**Re: Rice Marsh Lake Water Quality Improvement Project – Pay Application #2  
Barr Project # 23/27-0053.14-028**

**To:** Terry Jeffery – Interim RPBCWD Administrator  
**From:** Heather Lau, PE and Scott Sobiech, PE – Barr Engineering  
**Subject:** Rice Marsh Lake Water Quality Improvement Project – Change Order #1  
**Date:** January 20, 2022  
**Project:** 23/27-0053.14 028C  
**c:** Gavin Shaw – Meyer Contracting

# Change Order

Project: Rice Marsh Lake Water Quality Improvement Project	Owner: RPBCWD	Owner's Contract No.:
Contract: Rice Marsh Lake Water Quality Improvement Project		Date of Contract: August 23, 2021
Contractor: Meyer Contracting		Engineer's Project No.:23/27-0053.14-028C

**KRAKEN KF-10-16-72**  
MEMBRANE FILTRATION SYSTEM WITH PRETREATMENT  
STANDARD DETAIL

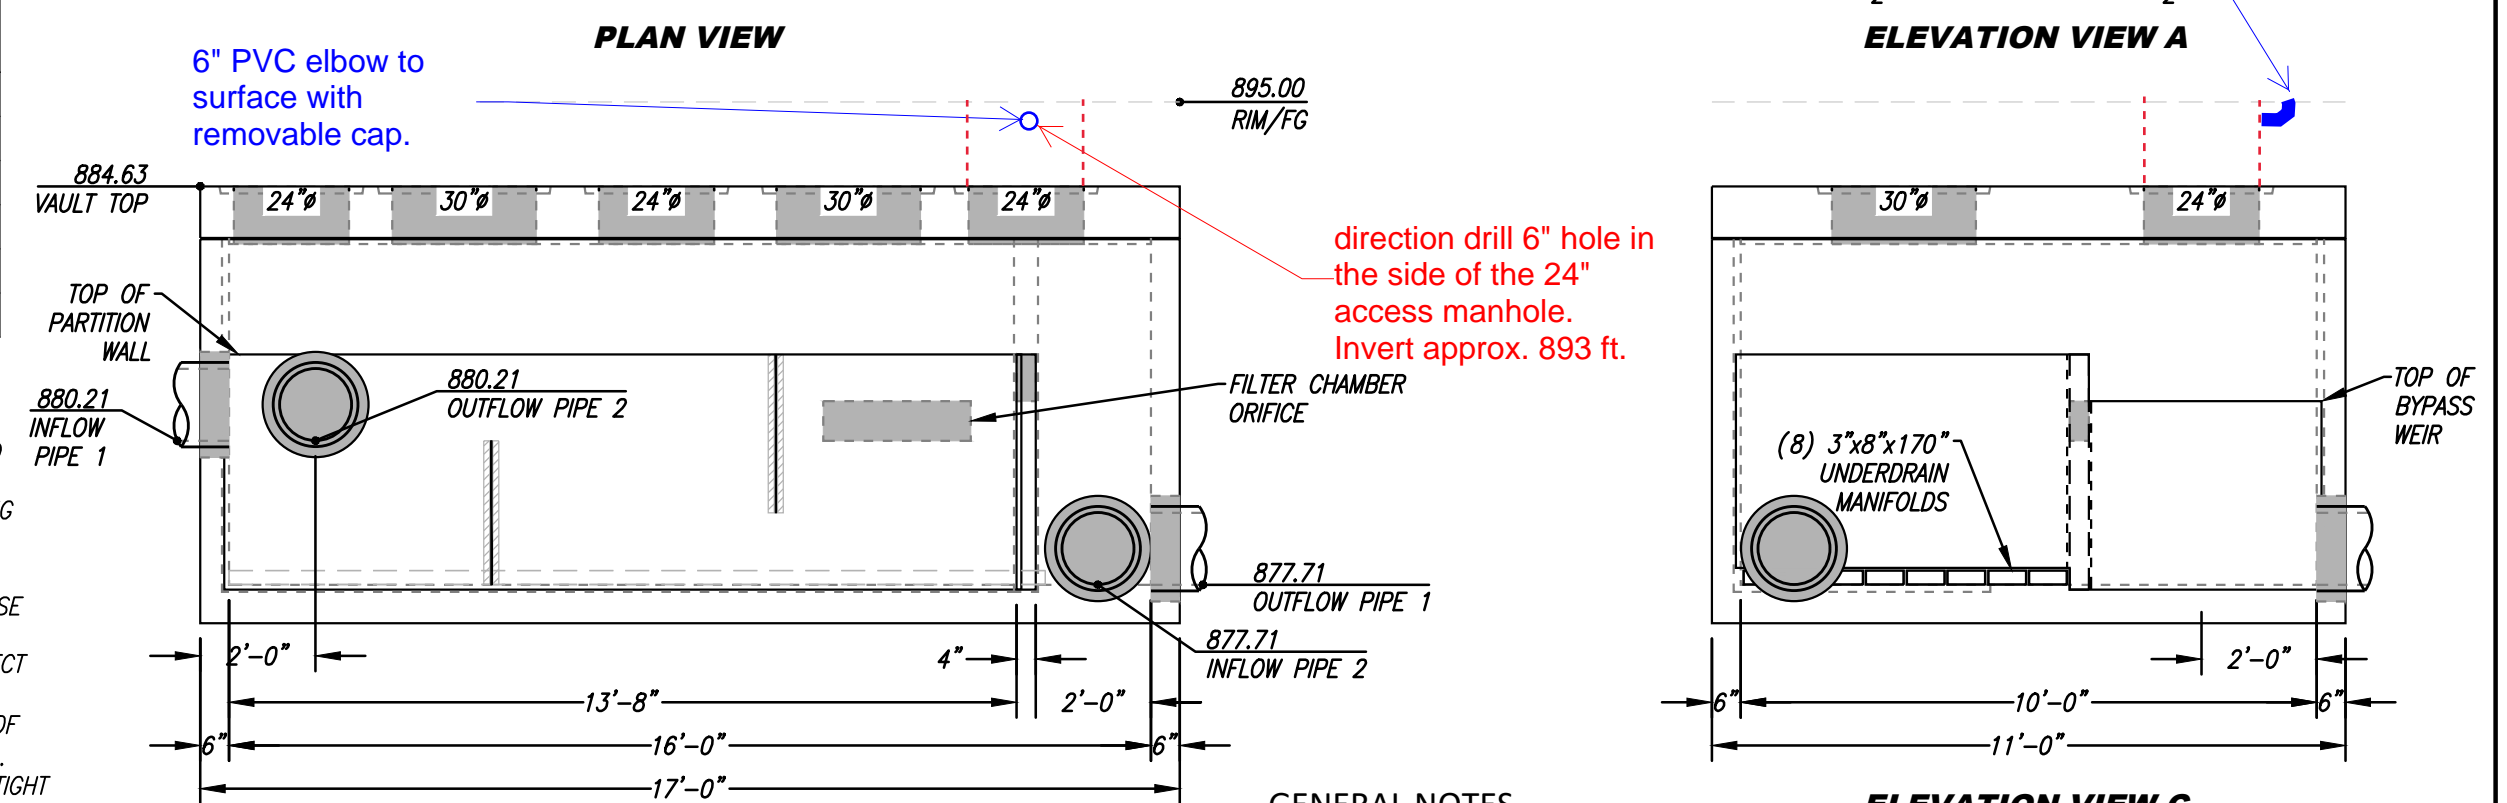
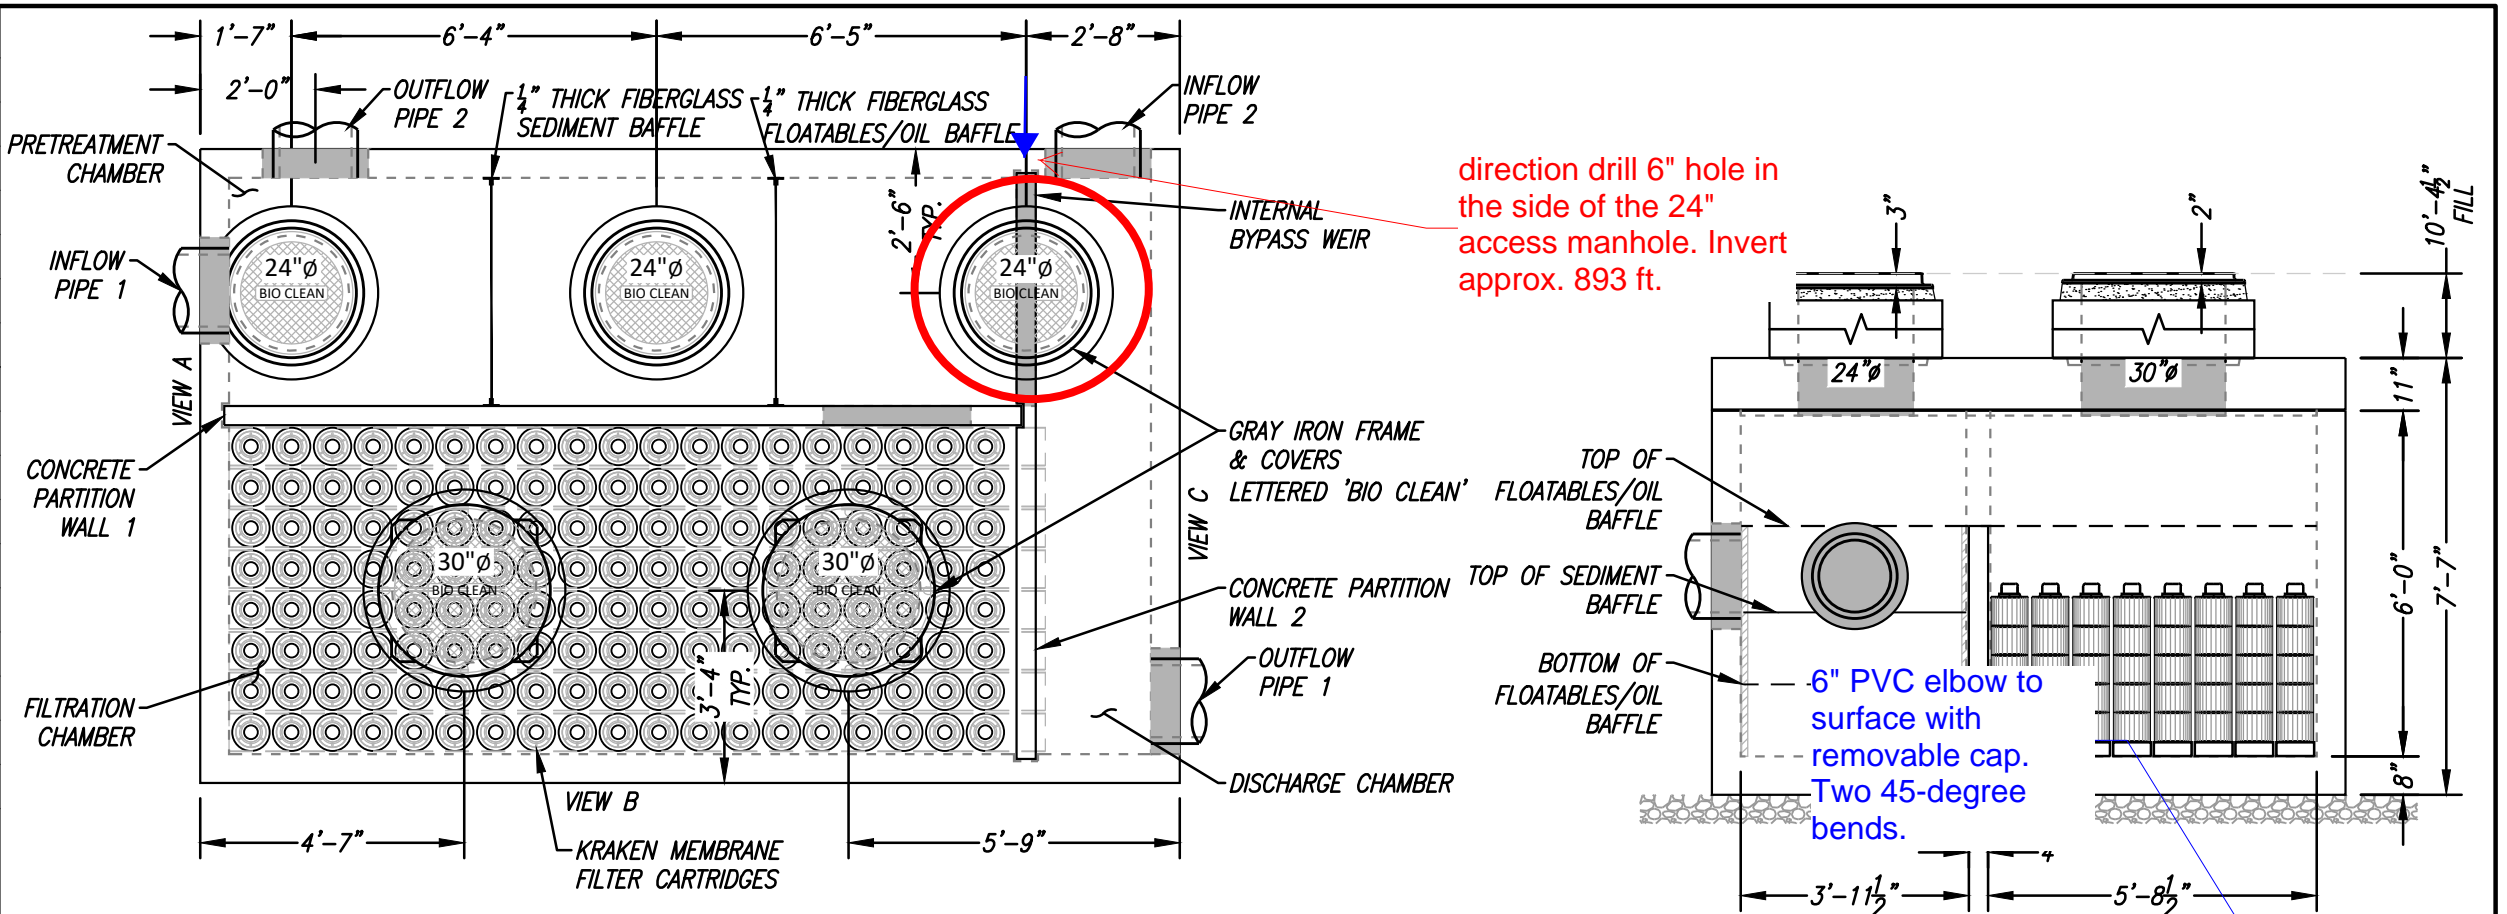
**Description:** Furnish and installing 10-LF of 6-inch PVC into the Kraken (STFS-1) riser for performance monitoring

**Reason for Change:** To provide a dedicated access port into the Kraken unit to allow RPBCWD the enhanced ability to monitor the performance of the underground stormwater treatment filtration system. The CONTRACTOR shall provide all equipment, materials, and labor for work related to the monitoring pipe installation as shown on the drawings in Attachment A.

**Contract Document Change:** The revised design results in the addition of item NN –PVC Piping for Monitoring based on the revised drawings as shown in Attachment A.

1. Core drilling into the Kraken Filtration Unit (STFS-1) riser
2. Installation of 10-LF of 6-inch PVC pipe and two 45-degree bends with cap
